**scheme 4: revisions to scheme 3**

**PROJECT**  
**The Hoo: Scheme 3**  
**17 Lyndhurst Gardens,**  
**Hampstead, London**  
 Grand Victorian House to Private Domestic Accommodation  
 NW3 5NU

**DRAWING**  
**First Floor Layout**  
**as Proposed**

JOB No	DRAWING No	REVISION
19013	1122	L

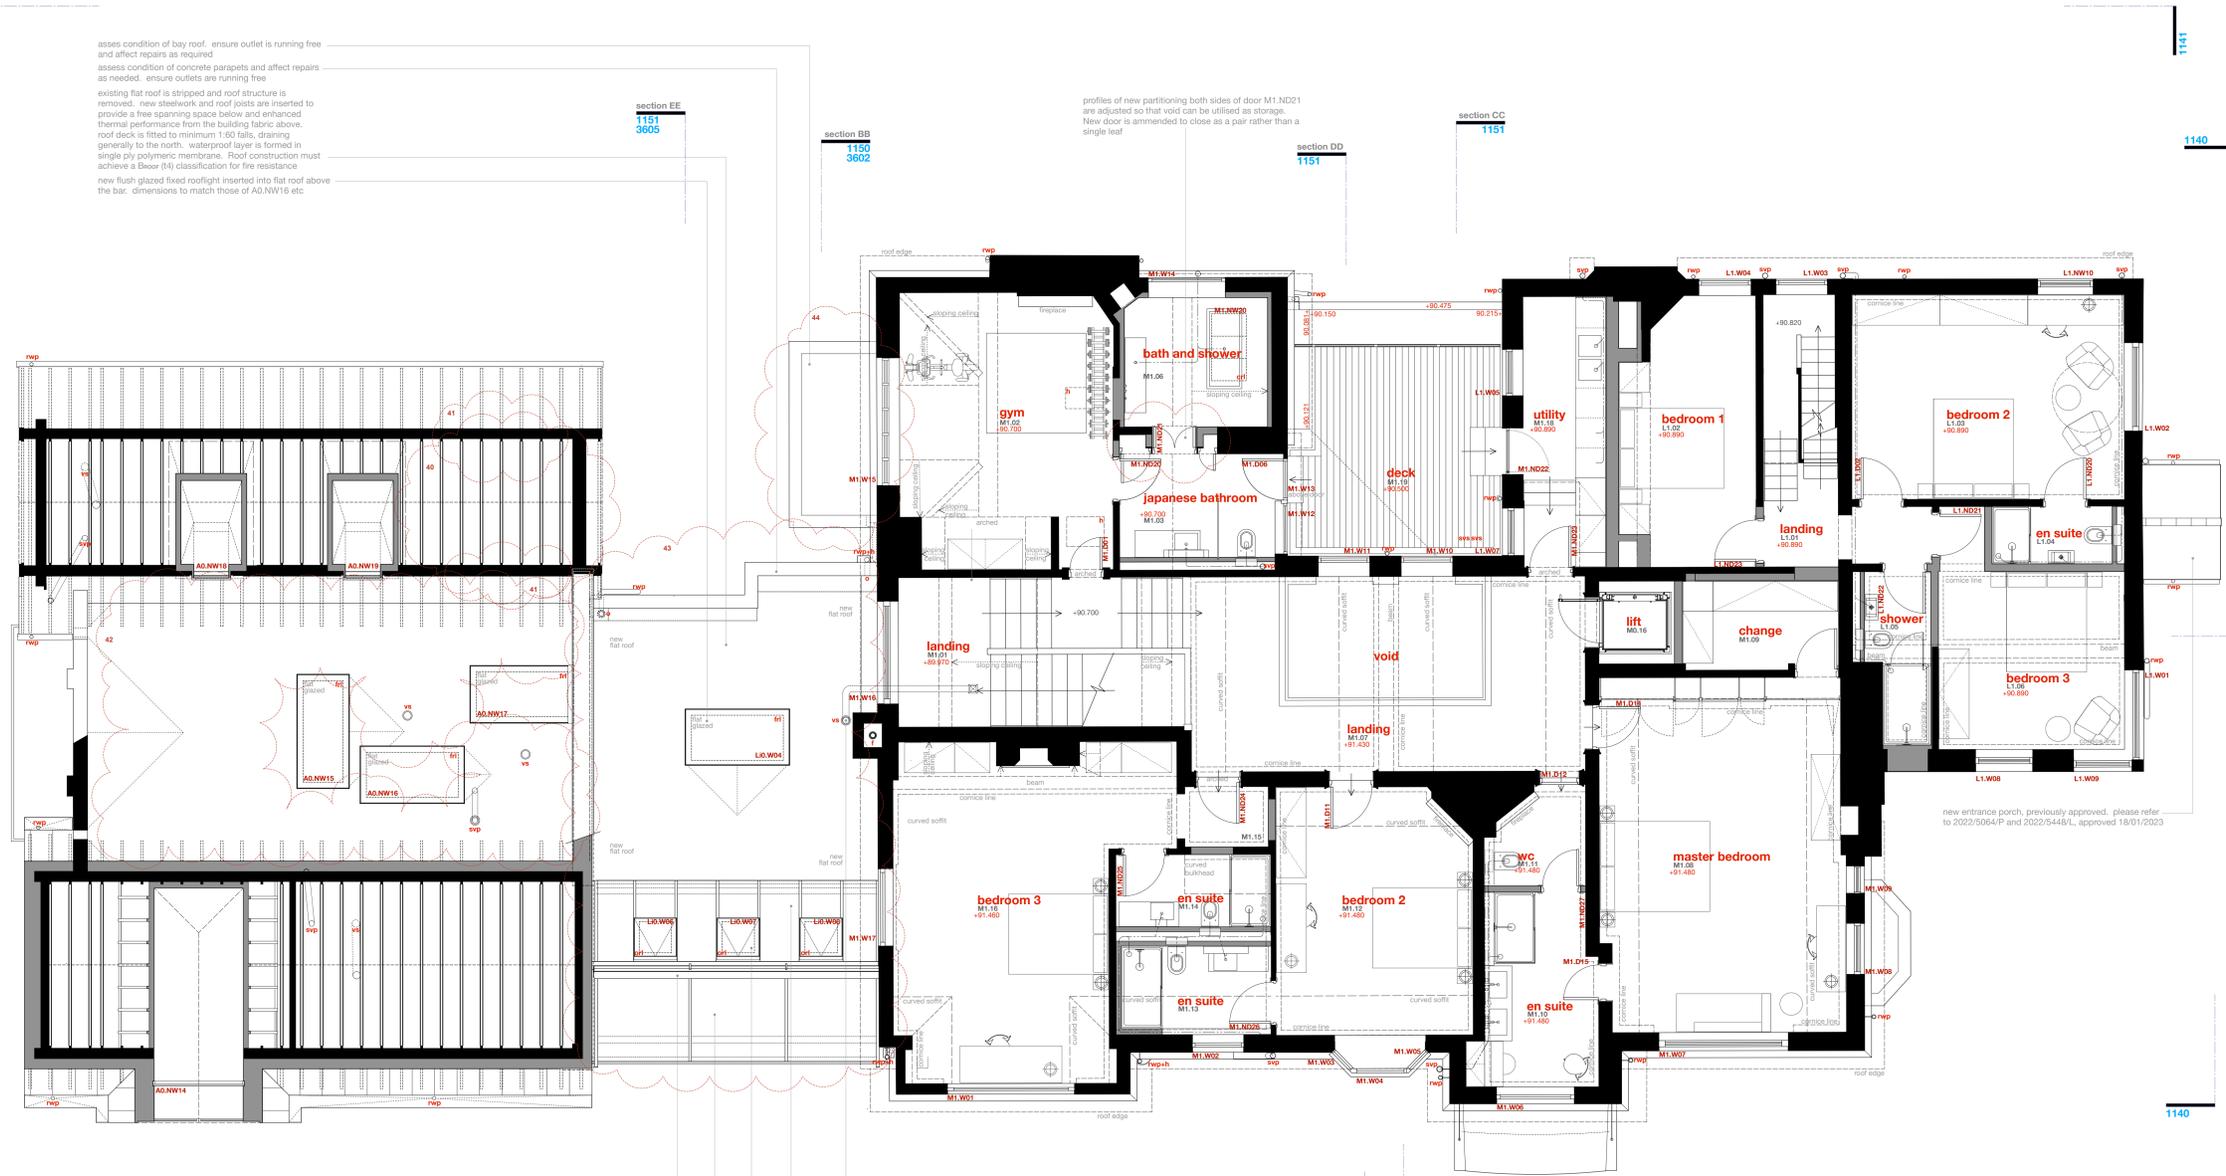
- 40 annex: the plant room that occupied roof space is omitted. plant controlled the climate of the contemporary link, which has also been omitted from the scheme, and is therefore no longer required.

- 41 annex: rooftop dormers containing plenum boxes are omitted.
- 42 annex: green roof is omitted from flat roof to reveal weatherproof single ply polymeric roof membrane.

- 43 link: proposals for contemporary new build link is omitted. revised scheme is simplified and reduced. amended design utilizes the volume and structure of the existing building and retains existing masonry facades to the north and south. flat roof and structure are removed and replaced with new incorporating improved thermal performance. single glazed glass roof and south elevation are removed and replaced with new double glazing fitted to powder coated aluminium frames. revised proposals are naturally ventilated and more simply heated.

- 44 main house: existing bay window, which was proposed for demolition in the previously approved scheme to accommodate the contemporary link, is retained to the application proposals.

- 45 main house: arrangement of new partitions revised so that former void can be utilized as storage. M1.ND.21 is altered to provide a pair of doors in preference to a single leaf.

asses condition of bay roof. ensure outlet is running free and affect repairs as required. assess condition of concrete parapets and affect repairs as needed. ensure outlets are running free.

existing flat roof is stripped and roof structure is removed. new steelwork and roof joists are inserted to provide a free spanning space below and enhanced thermal performance from the building fabric above. roof deck is fitted to minimum 150 falls, draining generally to the north. waterproof layer is formed in single ply polymeric membrane. Roof construction must achieve a Bower (N) classification for fire resistance.

new flush glazed fixed rooflight inserted into flat roof above the bar. dimensions to match those of A0.NW16 etc.

new ventilation stack servicing WC.07 is positioned out of sight when viewed from window M1.W16.

existing single glazed glass roof is removed and replaced with double glazed roof with powder coated aluminium frames. north facing roof is split into 7 bays, incorporating 3no opening roof lights to provide natural ventilation. glazing drains directly onto flat roof.

3no automatically opening roof lights fitted within north facing glass roof. opening mechanism is triggered by high humidity and temperature. rain protection and manual over-ride. roof lights are sized sufficiently to contribute to secure natural ventilation of the home office and bar areas.

existing single glazed glass roof is removed and replaced with double glazed roof with powder coated aluminium frames. south facing roof is split into 3 bays of fixed glazing. the glazing wide panes allow a much improved view from the home office into the garden, including up into the tree canopy.

externally mounted solar shading to south facing roof glazing only, automatically controlled. shading to moderate solar gain within the home office and control glare. shades are triggered by high heat and humidity measured within the home office, with wind protection and manual over-ride.
